Re: D.H.C. FOUNDATION INVESTIGATION REPORT -
Bridge Site No. 1B-2, Hwy. #41 at Hydes
Creek, 2.7 Mi. S. of Griffith, Dist. #10,
N.J. 62-P-111 -- W.P. 225-60.

W.P. 225-60,
Hydes Creek Bridges,
Bridge Site #18-2,
2.7 Miles South of Griffith,
Hwy. #41, District #10.

We have reviewed the Preliminary Plan
for the above structure and herewith, submit our
comments for your consideration:

DEPARTMENT OF HIGHWAYS ONTARIO			
BRIDGE 15/11			
HYDES RIVER BRIDGE			
2.7 MILES SOUTH OF GRIFFITH			
KING'S HIGHWAY No. 41 LINE J-1		DIST. No. 10	
CO. LENNOX & ADDINGTON		CON. 15	
TWP. DENBIGH		LOT 4	
PRELIMINARY PLAN			
APPROVED		SITE No. 18-2	
BRIDGE ENGINEER		W.P. No. 225-60	
DESIGN	M. M. CHECK	CONTRACT	No.
DRAWING	R. E. CHECK	DATE	No.
DATE	DEC. 1962	LOADING	H 20 S 16
DRAWING No.		D-5177-PI

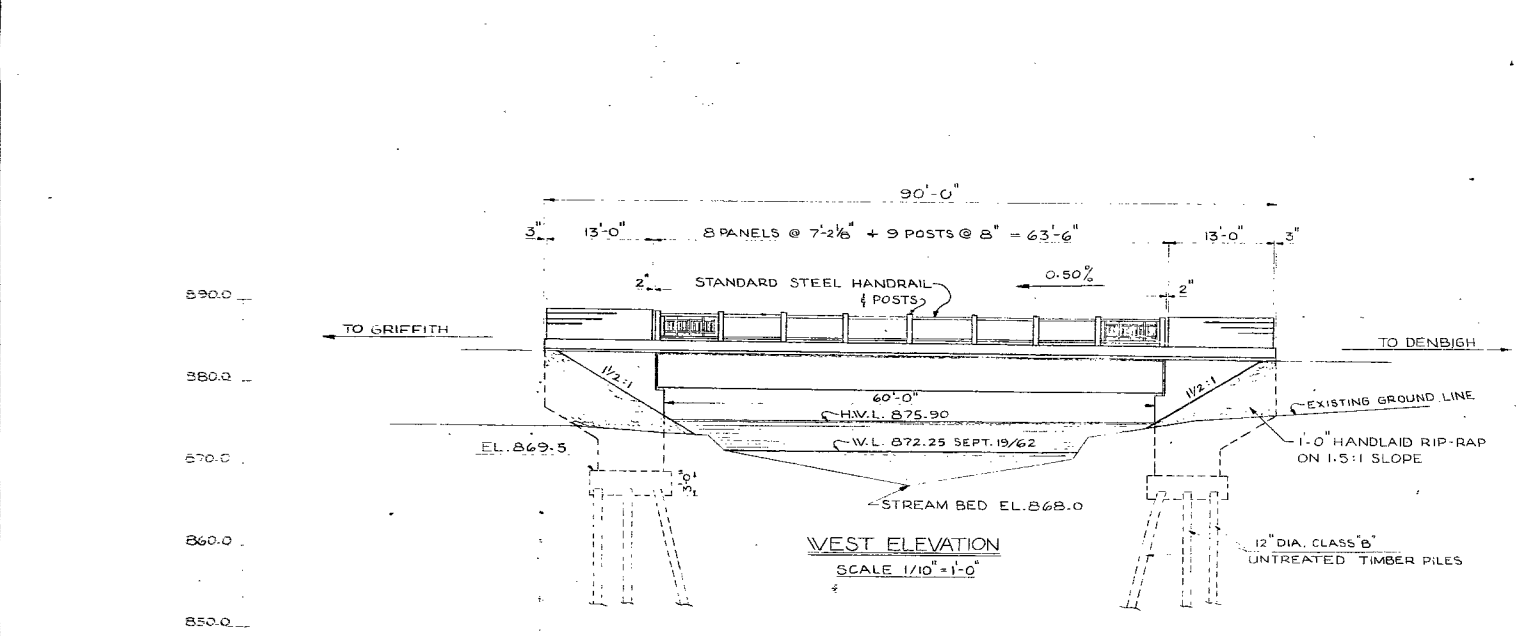
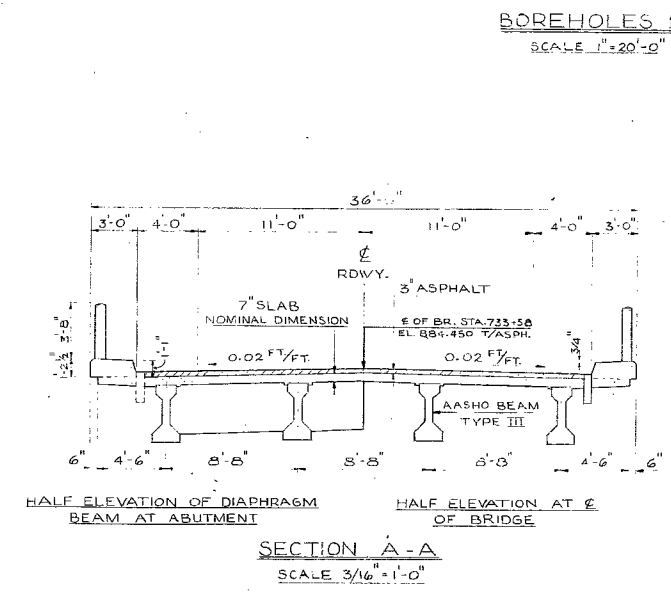
Because of the granular character of
the subsoil and the proximity of the stream bed to the
footing excavation, dewatering may create quite a problem.

Therefore, we would suggest that a note
be put on the drawing or in the Contract, in which the
Contractor's attention is drawn to the necessity of
applying an appropriate dewatering scheme.

It is felt that this matter of dewatering
can best be covered in the contract rather than
putting a note on the drawing D-5153.
